**Re: Transportation Engineering Design Standards Exemption Request
Ashbury Heights Subdivision Cul-De-Sac Radius**

RE: *Design Exception #04-07, Ashbury Heights – 28 ¼ & Grand Falls Drive
TEDS Exceptions for Cul de Sac Length*

DESIGN EXCEPTION # 04-07

title: **ALTERNATIVE A: 48-FT RADIUS
SID COURT TEDS REQUEST**
 By: **mra**
 Date: **12-14-06** Scale: **1"=50'**

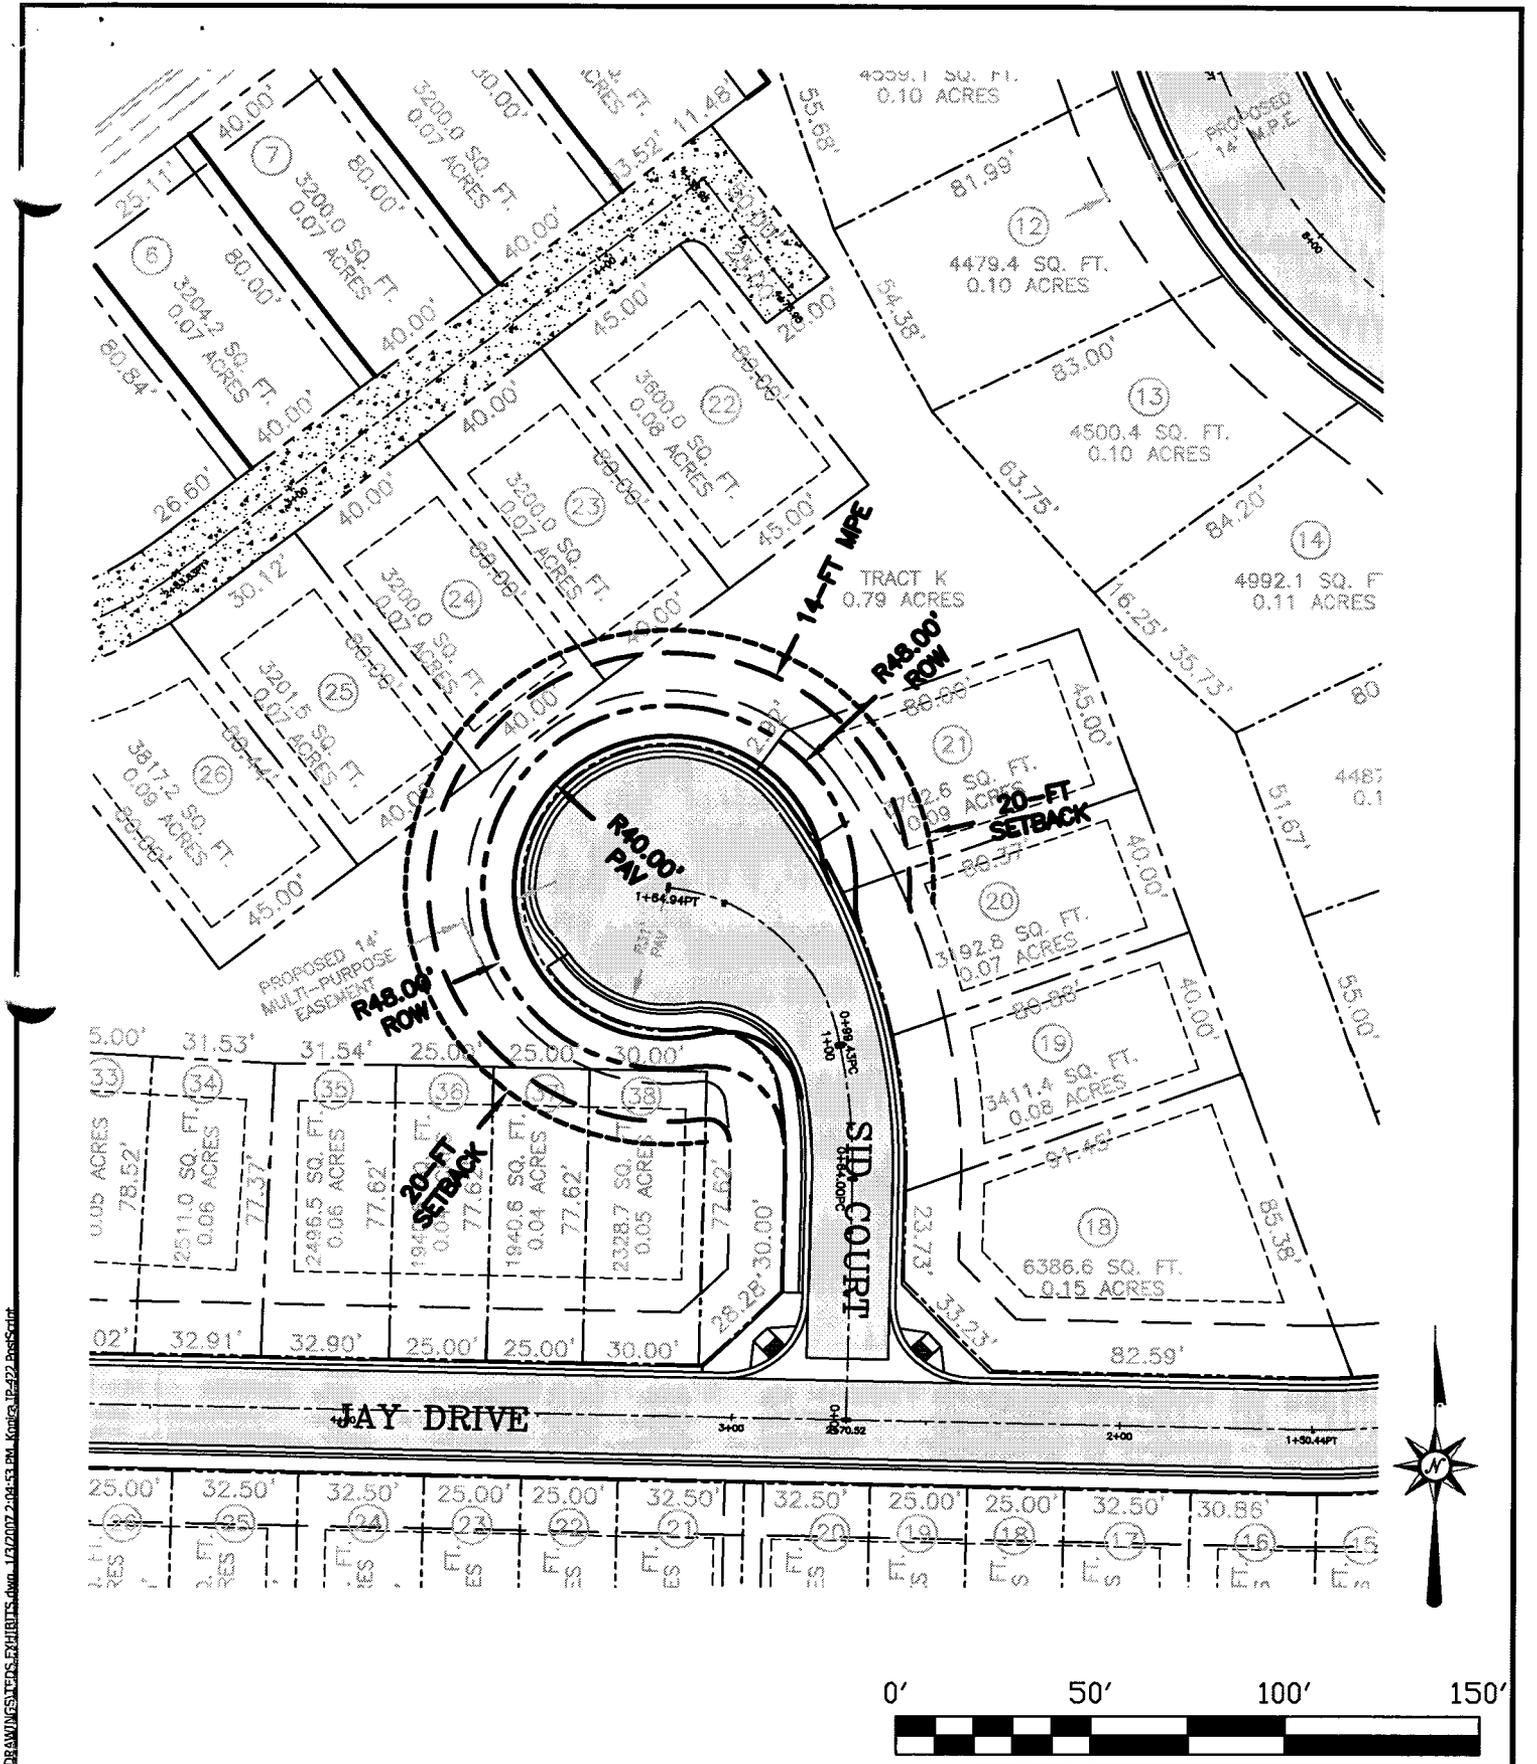
Alternative A, attached to this request, would be to construct a cul-de-sac with a 48-ft radius. This alternative complies with the TEDS requirement but the additional right-of-way width and subsequent 20-ft front yard set back significantly impacts four building sites around the cul-de-sac.

title: **ALTERNATIVE B.1 - 150-FT LENGTH SID COURT TEDS REQUEST**
 By: **mra**
 Date: **12-14-06** Scale: **1"=50'**

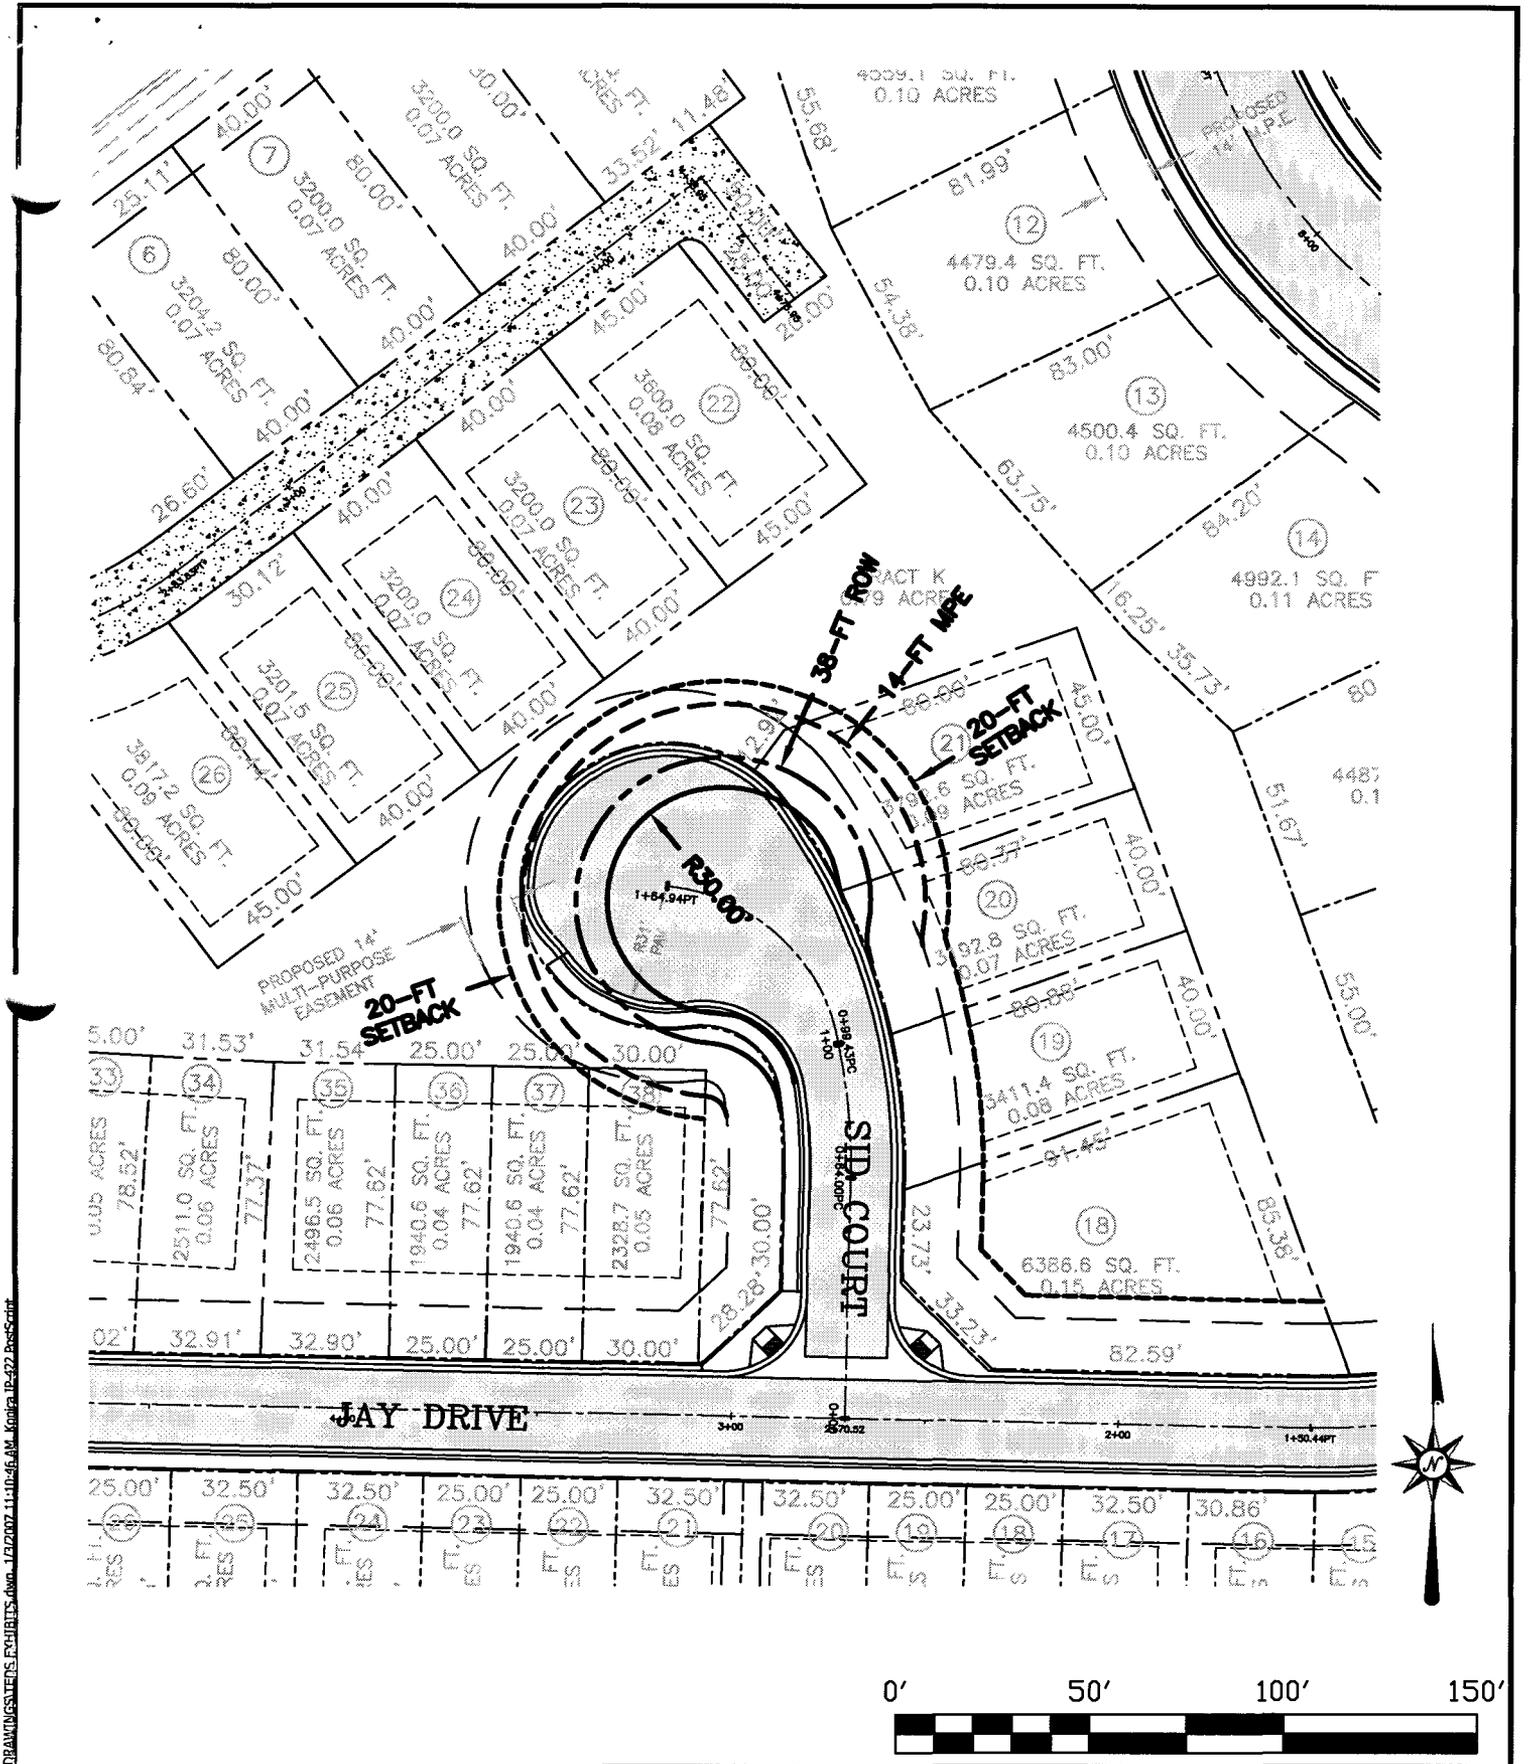
Alternative B.1 and B.2, attached to this request, would be to construct a 150-ft long street with a 38-ft radius cul-de-sac. This alternative complies with the TEDS requirement but the additional right-of-way width and subsequent 20-ft front yard set back significantly impacts two building sites around the cul-de-sac.

title: **ALTERNATIVE C
SID COURT PROPOSED DESIGN**
 By: **mra**
 Date: **12-14-06** Scale: **1"=50'**

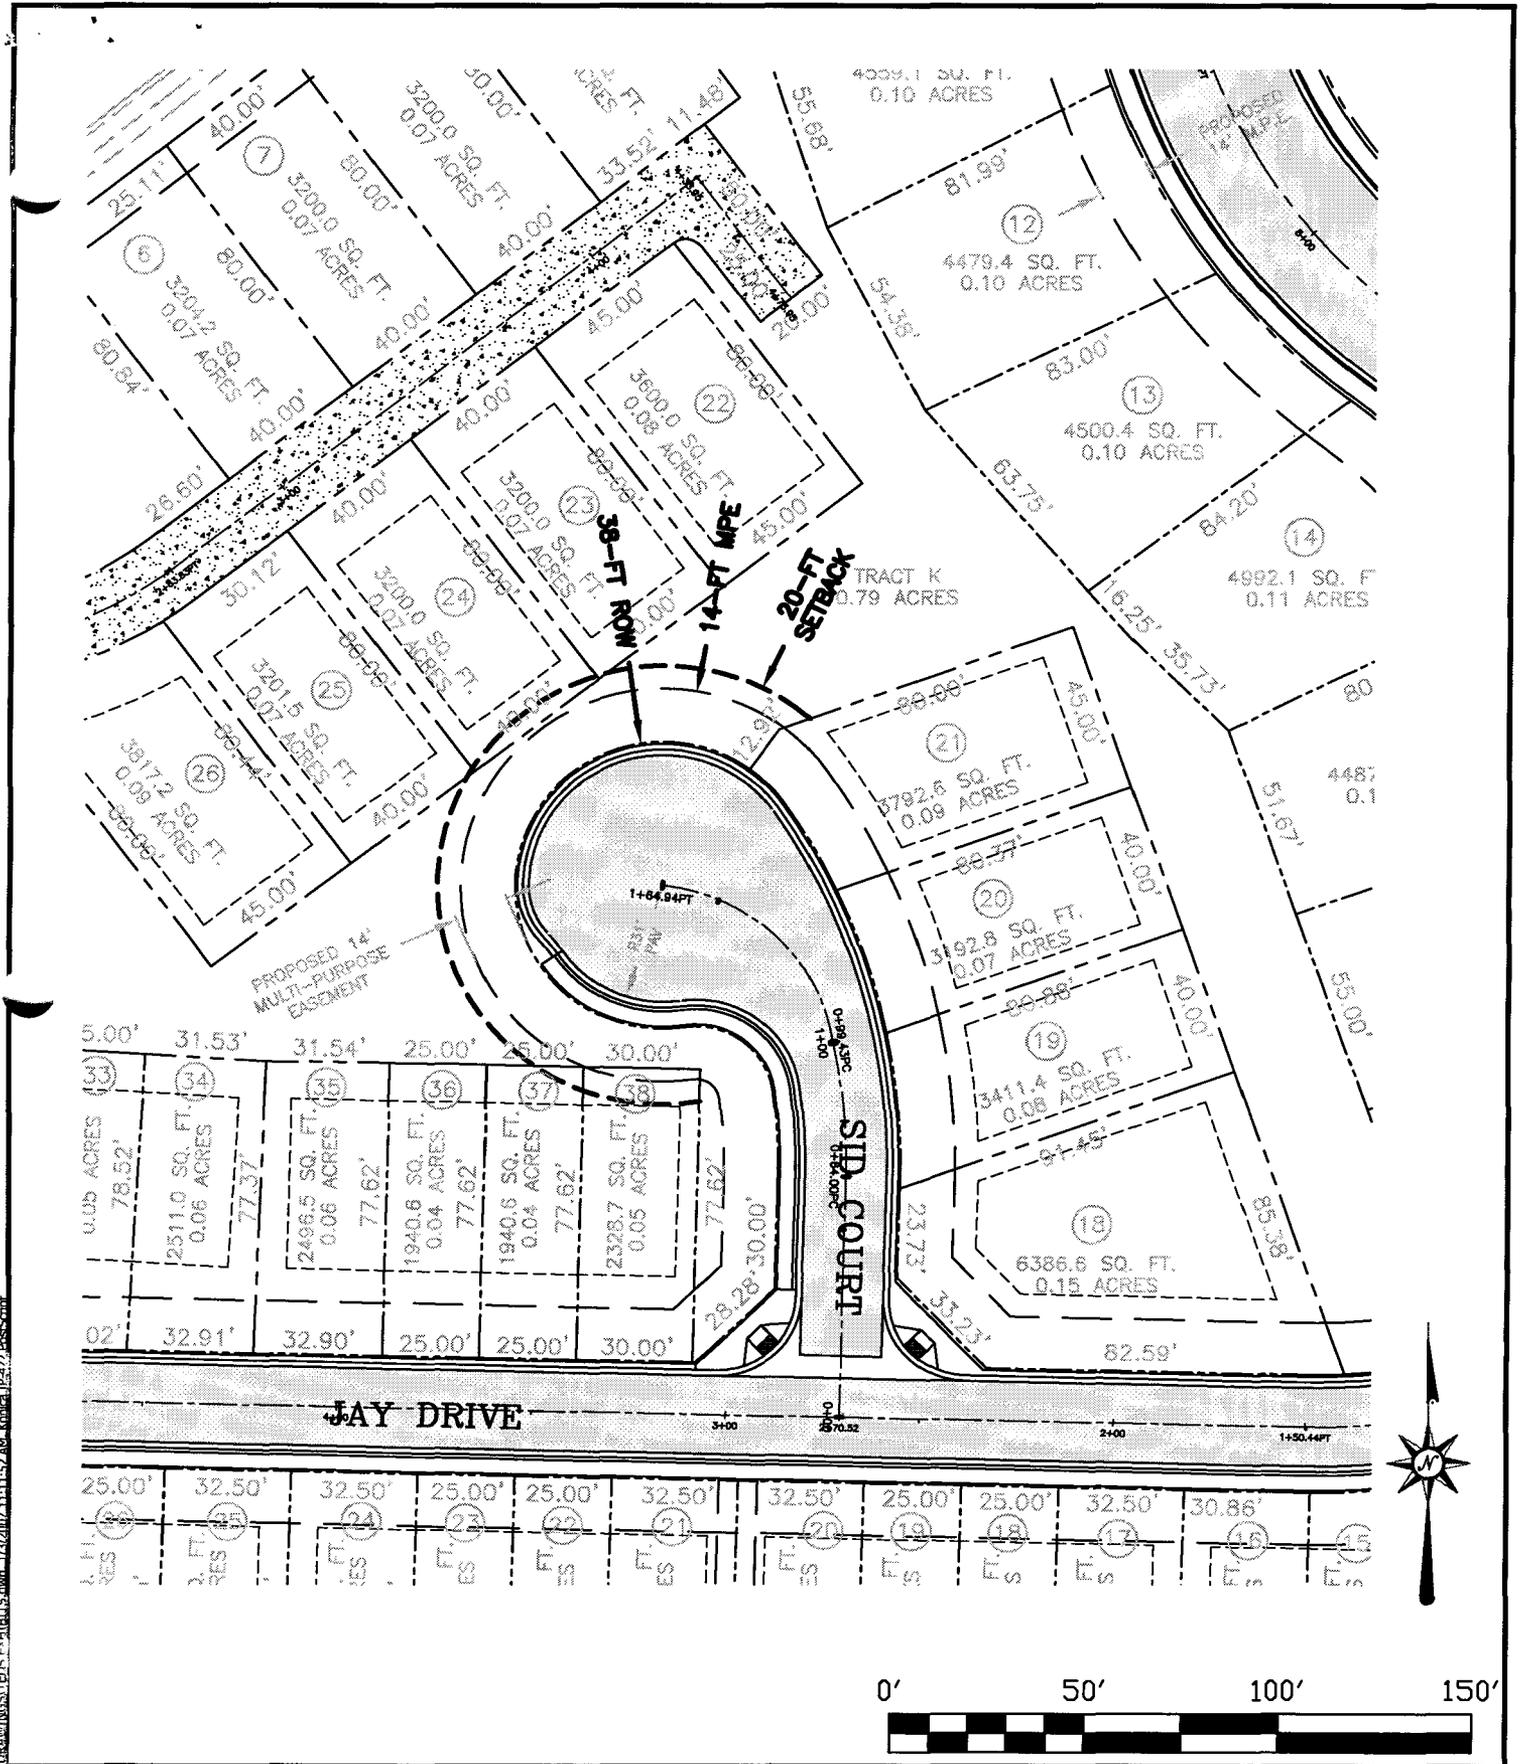
Alternative C, the preferred alternative which is also attached to this request, would be to construct a 165-ft long street with a 38-ft radius cul-de-sac. This alternative does not comply with the TEDS requirement because the street is 15-ft to long. From a transportation safety standpoint, a street with a 38-ft radius cul-de-sac that exceeds the TEDS length requirement by 15-ft has no impact on the street safety or capacity. However, the 150-ft length requirement does have an impact from a fire protection standpoint. Section 503.1.1 of the 2000 International Fire Code (IFC) states:

Therefore, to address the fire safety issues associated with the additional 15-ft length in the street, the Asbury Heights Subdivision will require all townhouse and patio home units constructed within the subdivision to have approved fire sprinkler systems. This condition can be placed by the City of Grand Junction as part of the preliminary plan approval for the project.

#1 Access Their cul de sac is 165' long and they are requesting to use the 38' radius instead of the required 48' radius.

Please find attached the committee's decision for the above referenced request. This design exception was approved as requested.
